2015-07-06

**Rework instruction for Sirius / UltraPower motor fan unit change**

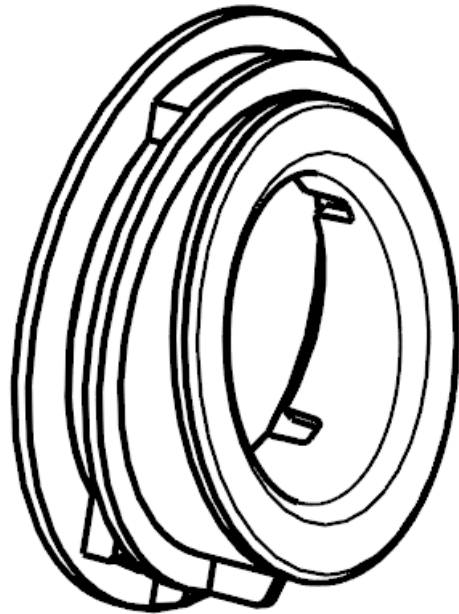
Change over suspension ring on fan unit 2198230-19 (219890001 SUSPENS RING UPO BLA) with the one used on 2198230-04 (118331401 SUSPENS RING UPO BLA).

After that it can built into cleaner.

**118331401 SUSPENS RING UPO BLA  
OK for service**

**219890001 SUSPENS RING UPO BLA  
NOT OK for service**
